Architectural Addendum No. 03

date July 6, 2026

project University of Toronto – Dentistry Clinic 2 Renovation

**project/file
no.** 24082 (UofT Project Number: P065-21-050)

2 PATIENT LOBBY - REFLECTED CEILING PLAN
1 : 100

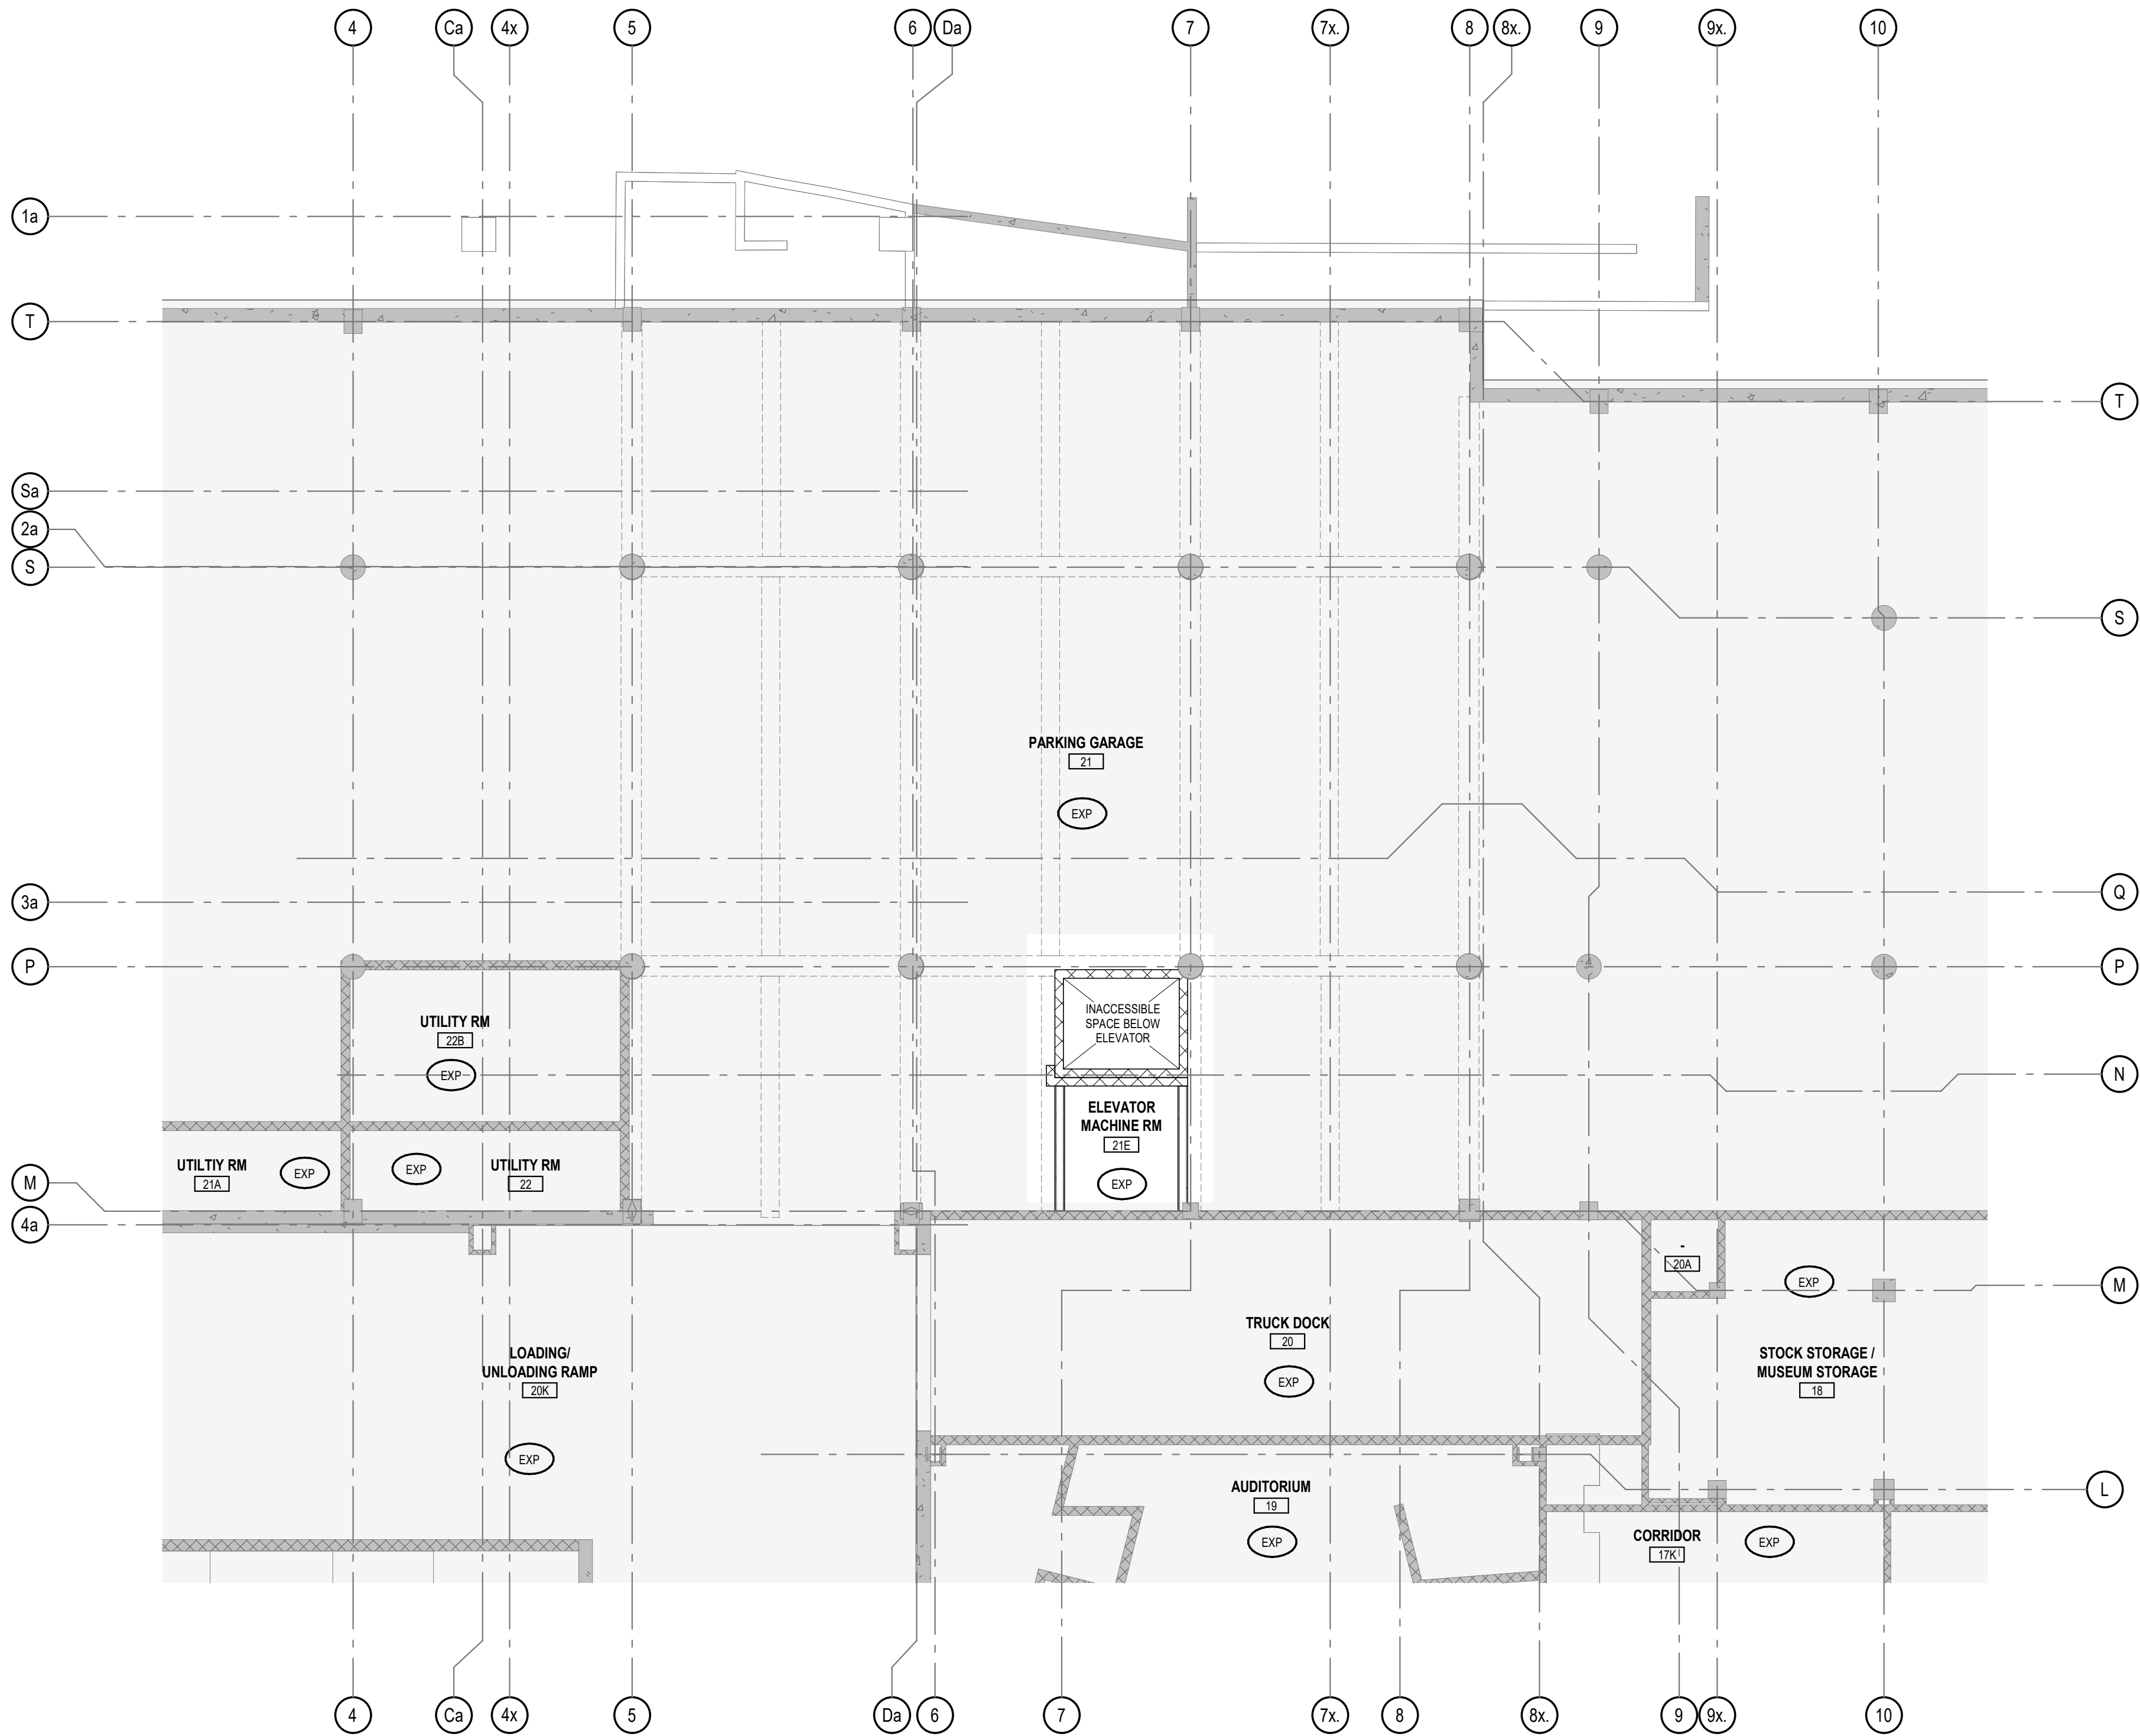
B1. Sheet A1501 – Patient Lobby & Parking Garage Reflected Ceiling Plans

- B1.1.** Drawing 2/A1501 – **ADD** EXP exposed ceiling tag to south east portion of ceiling in Waiting Room/Lobby (M200).
- B1.2.** Drawing 2/A1501 – **ADD** Renovation Keynote R22 to south east portion of ceiling in Waiting Room/Lobby (M200).
- B1.3.** Renovation Keynotes – **ADD** Renovation Keynote R22.
- B1.4.** Reflected Ceiling Plan Legend – **REMOVE** “Refer to finish schedule for paint” note under Exposed Ceiling.

5 SECTION - LEVEL 1 CORRIDOR
1 : 20

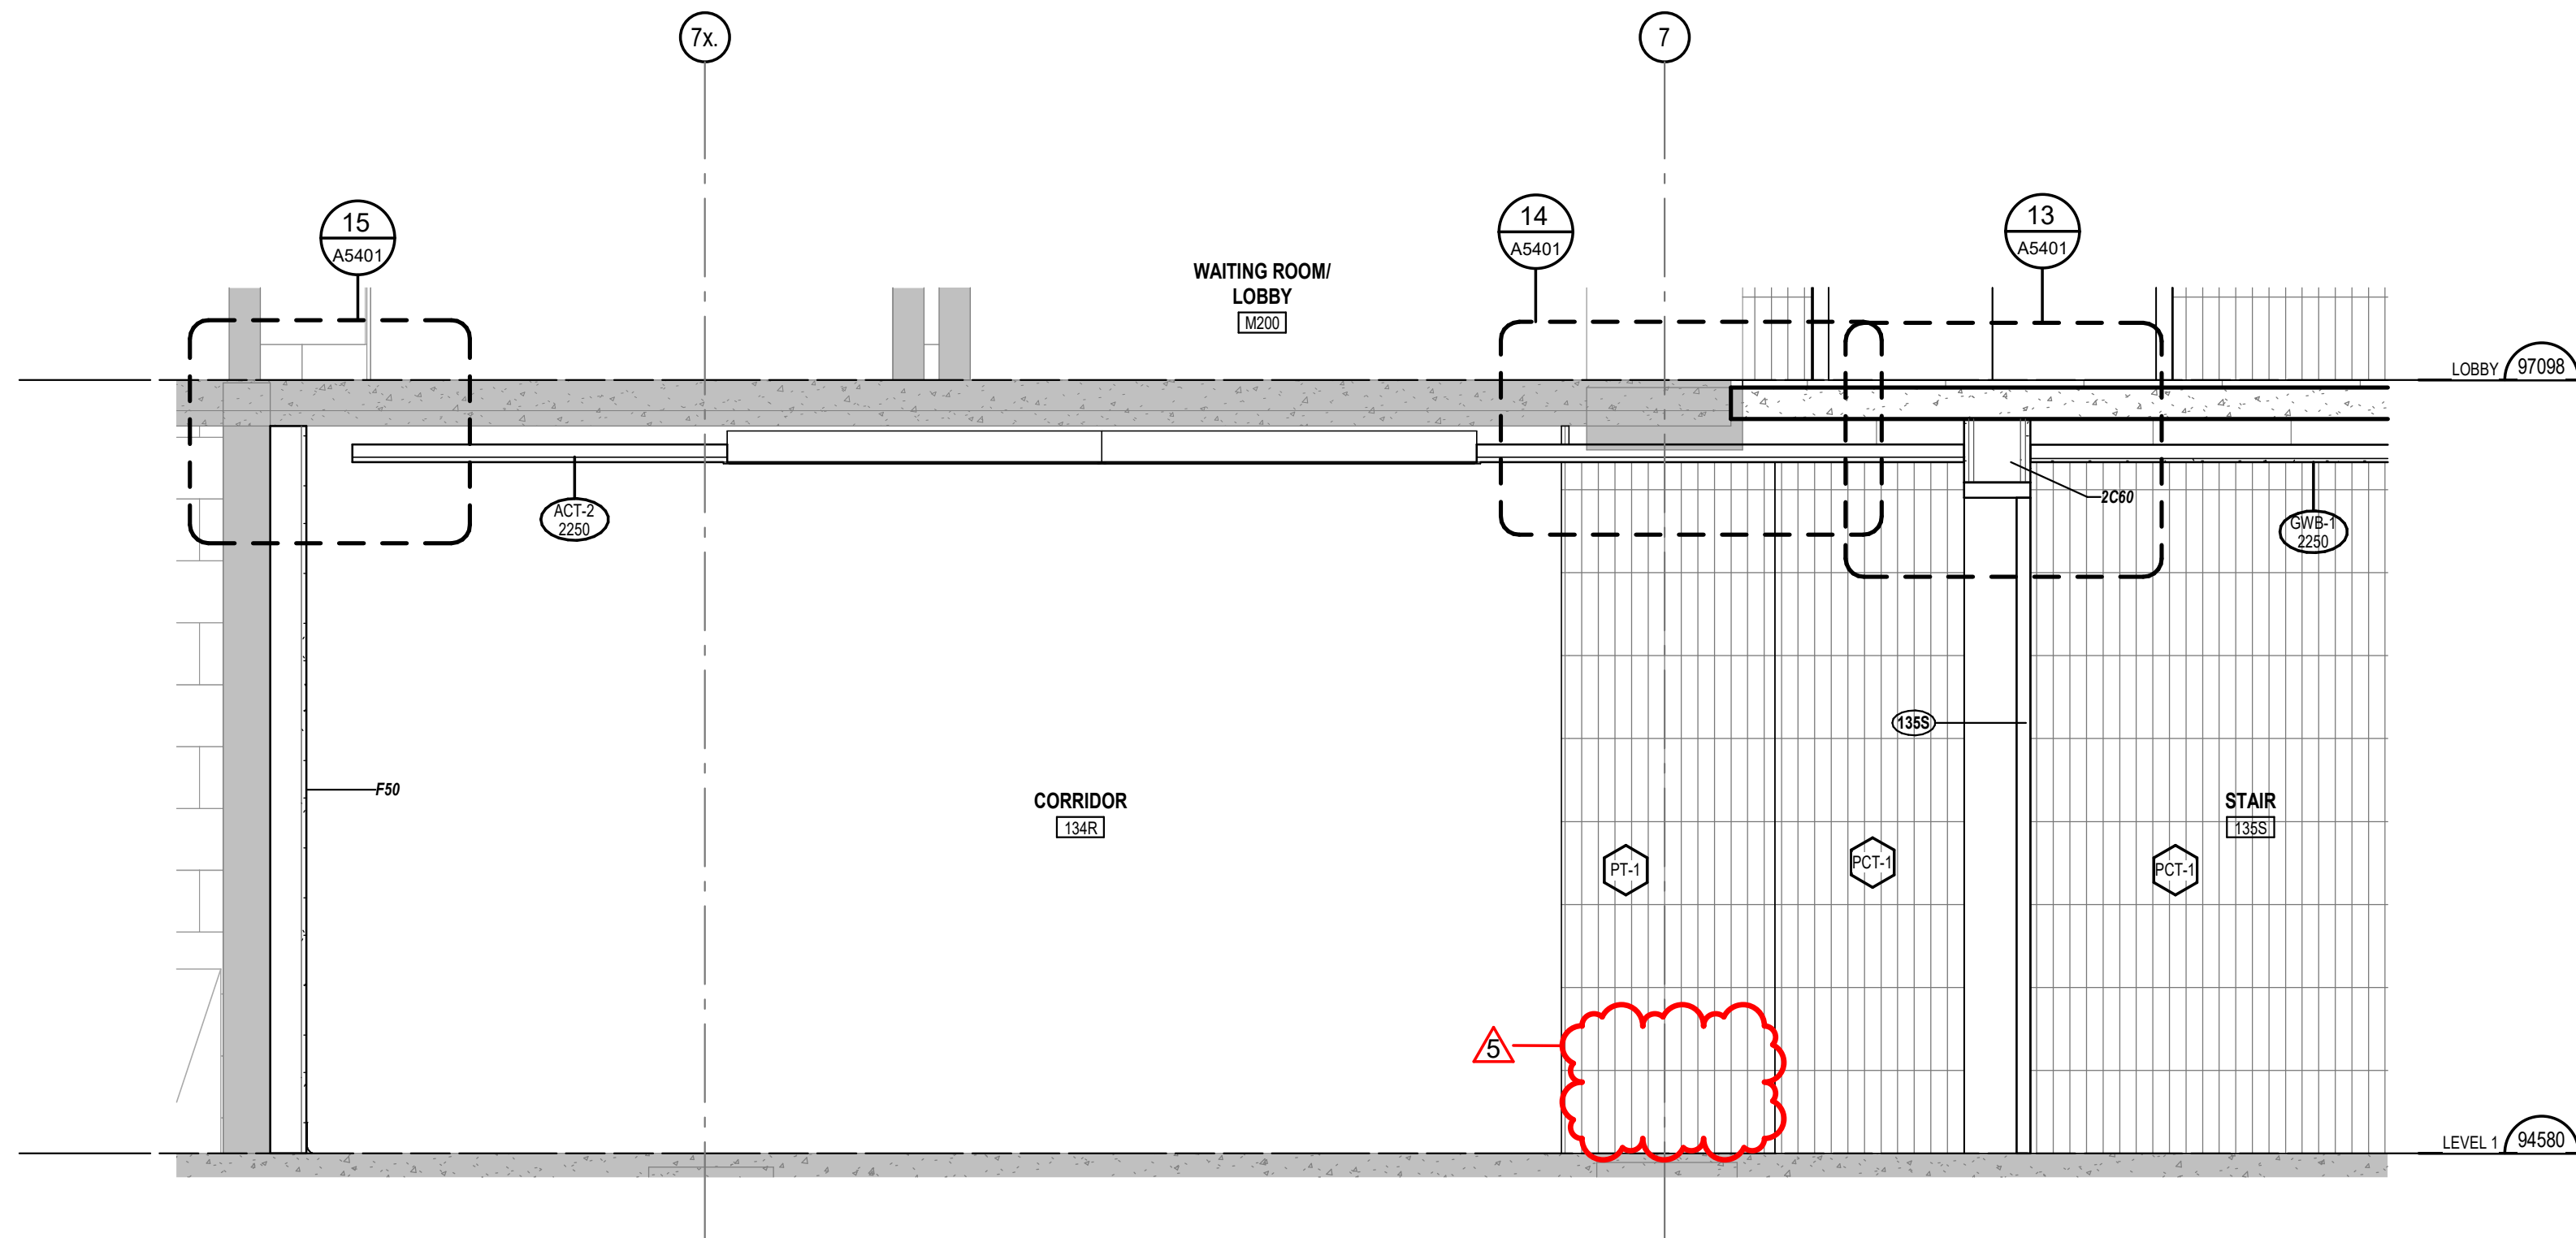
B5. A3302 – Wall Sections – Patient Lobby

- B5.1.** Drawing 5/A3302 – **REMOVE** RB1 resilient base.

SCHEDULE - DOORS AND
SCREENS

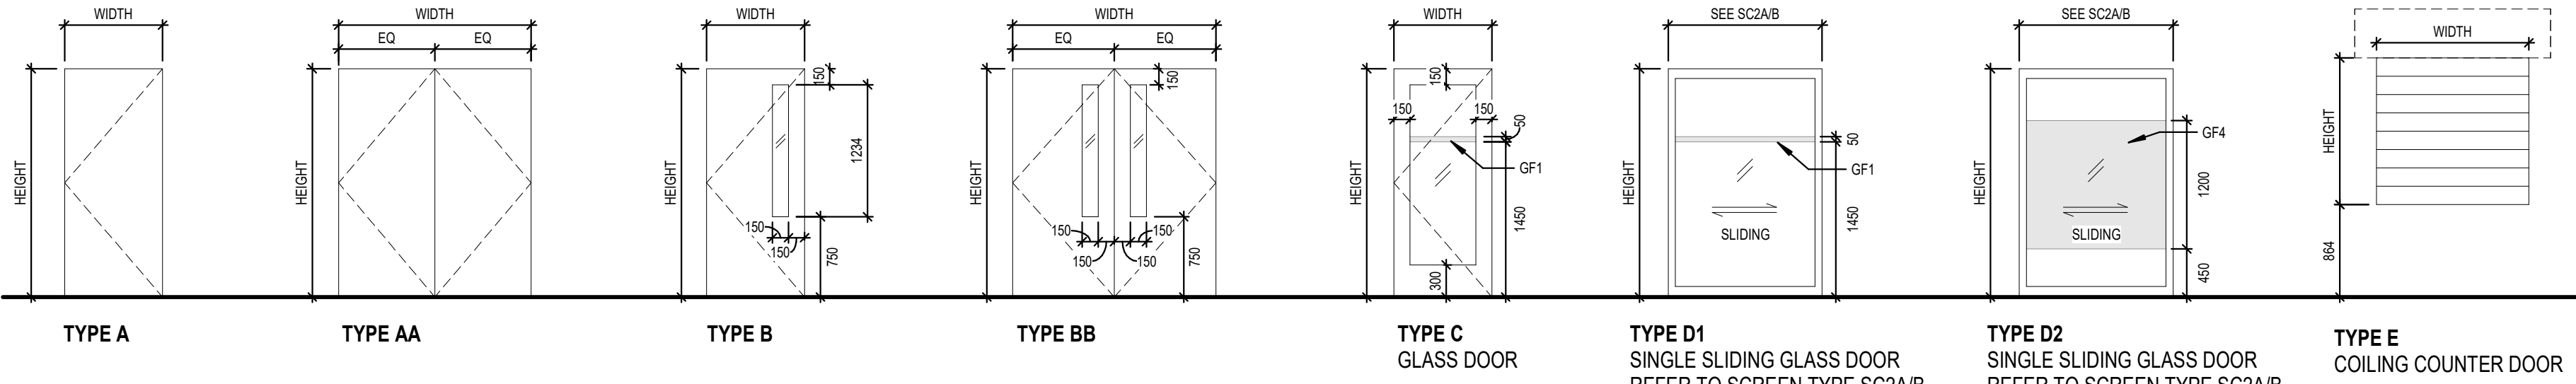
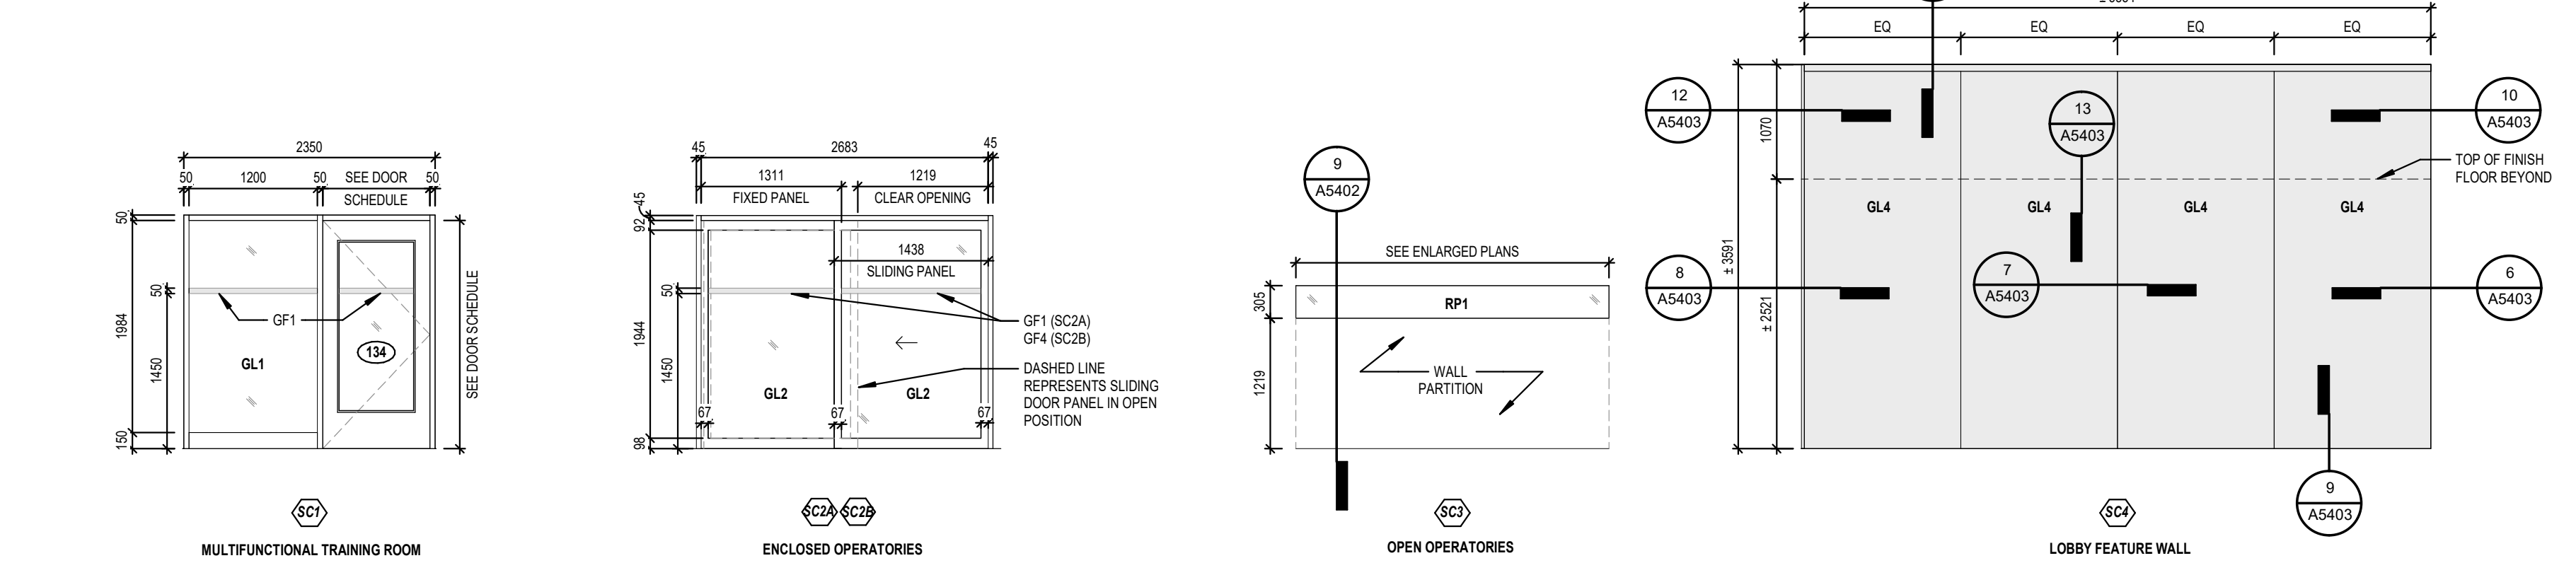
B7. A6102 – Schedule – Doors and Screens

- B7.1.** Door Schedule – **REVISE** panel type from A to B for doors 135K, 202K, 202V, and 219.
- B7.2.** Door Schedule – **REMOVE** glazing from door 226C.

CONTROLS SCHEMATICS #1

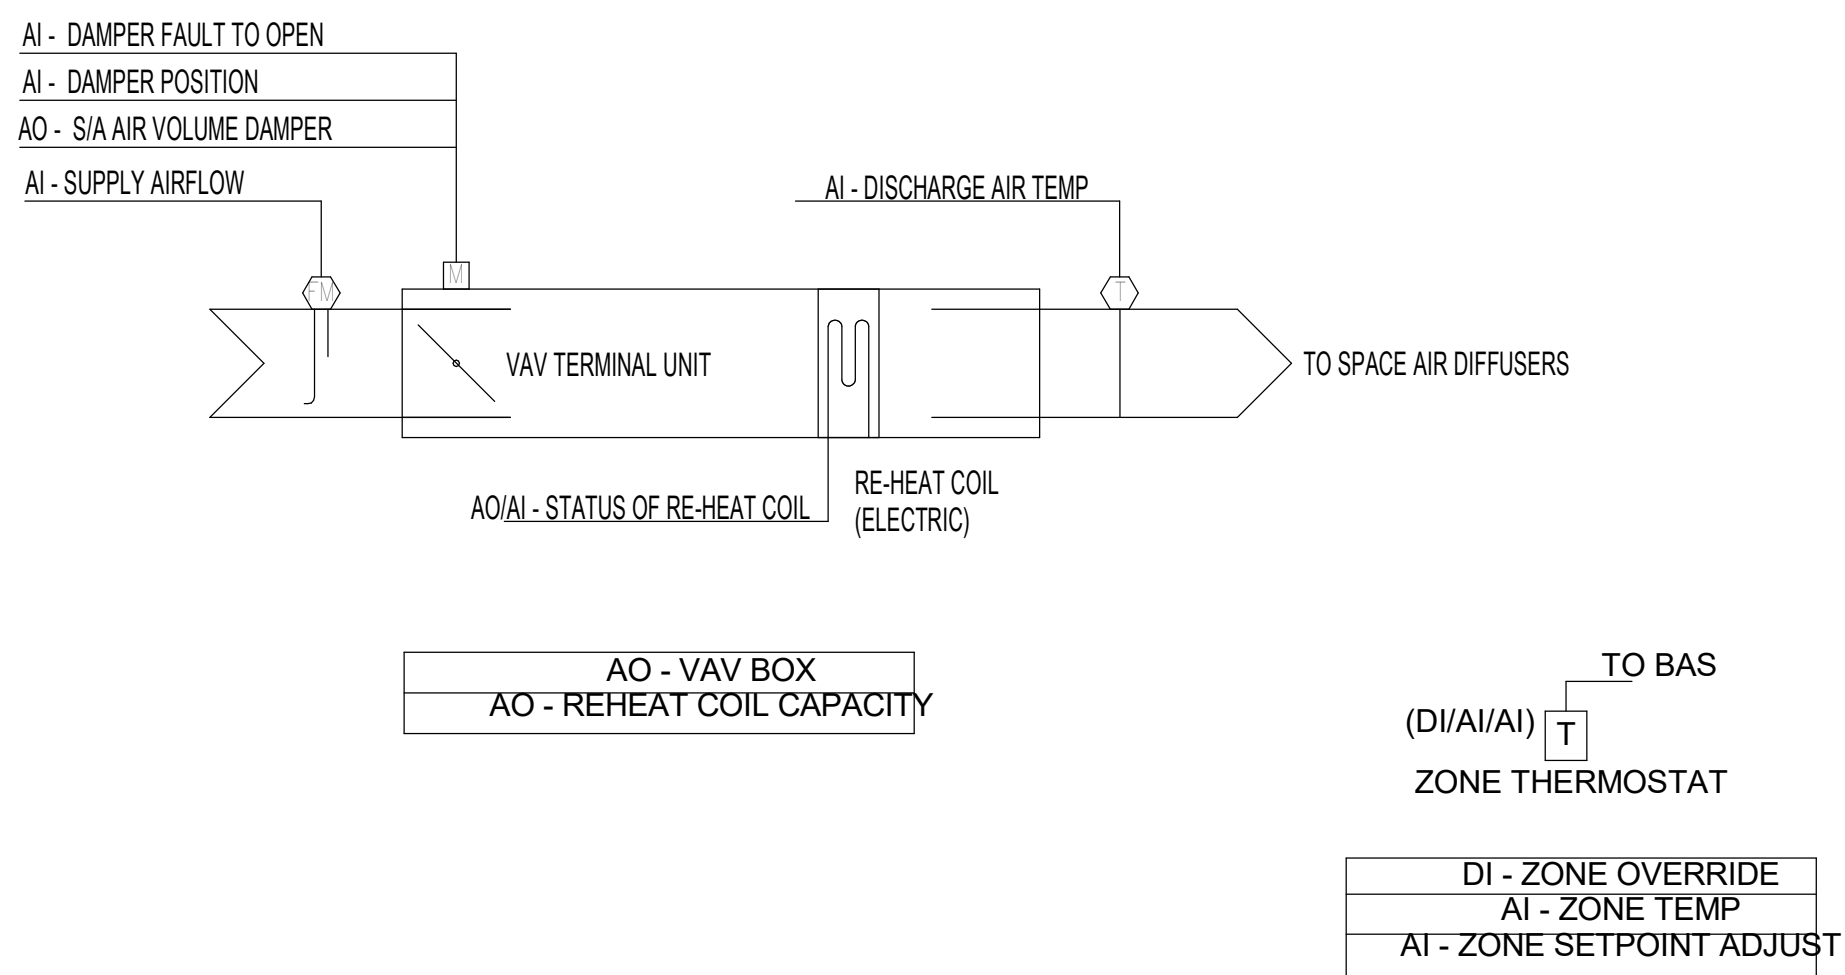
1.1. M-603: control schematics #1

1.1.1. Condensing units tag updated.
